Service Bulletin

MAZDA

| Category 15 | Applicable Model/s (see below) | Subject IMPROPER OPERATION OF POWER WINDOW REGULATOR (Ball Type) | Bulletin No. 071/88 Issued 11/30/88 Revised |

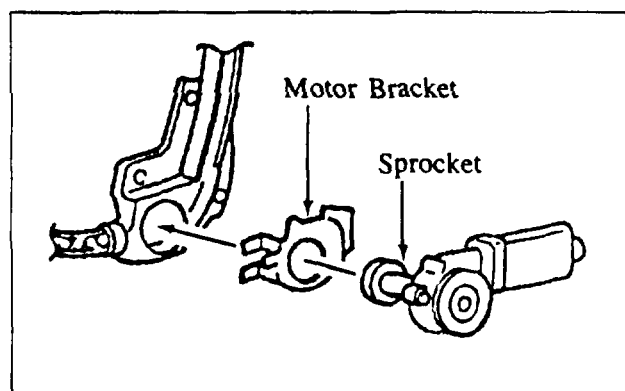
3. Install the disconnected power window motor to the new regulator assembly with a new motor bracket and sprocket.

It is not necessary to replace the motor bracket for 323/323W and RX-7.

626 Front

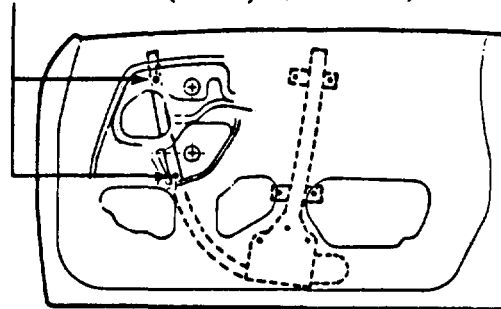
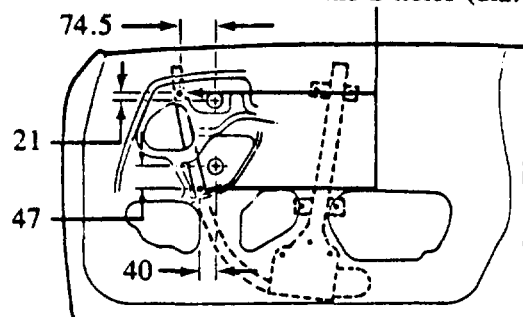
4. Change the hose routing as follows: (626 front & rear doors, 929 front door only)

- Make two holes (0.27in or 7mm dia.) at the points indicated by the arrows.
- Remove the burr around the holes by filing.
- Apply sealant around the holes for rust prevention.
- Install the regulator assembly to the door and route the hose as shown.

Make 2 holes (dia. 7). (Unit: mm)

- Fix the hose at the two holes. Adjust clip location to ensure an even curve in the hose.

626 Rear

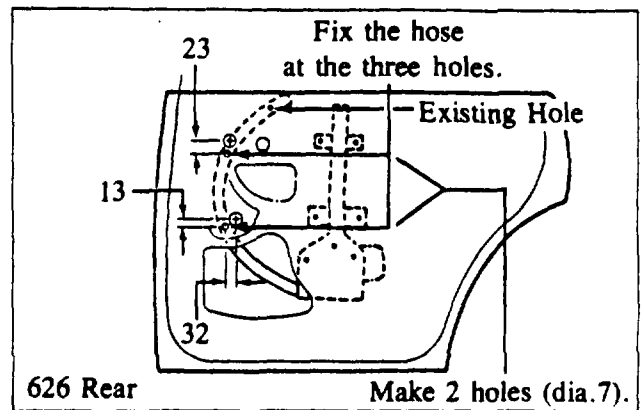
1. Locate the hose at the inner panel corner as shown.
2. Adjust the clip location to ensure an even curve in the hose.

929 Front

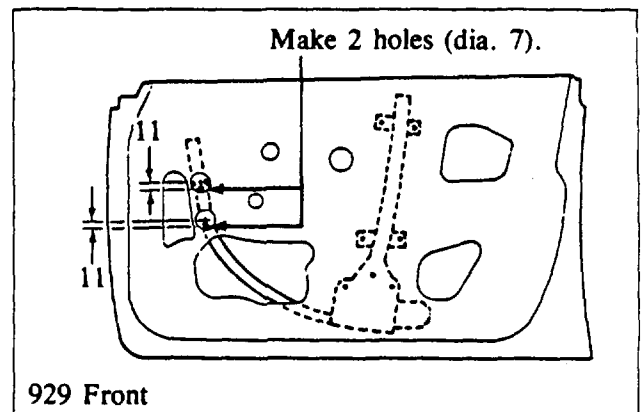
1. Fix the hose at the two holes. Adjust the clip location to ensure an even curve in the hose.
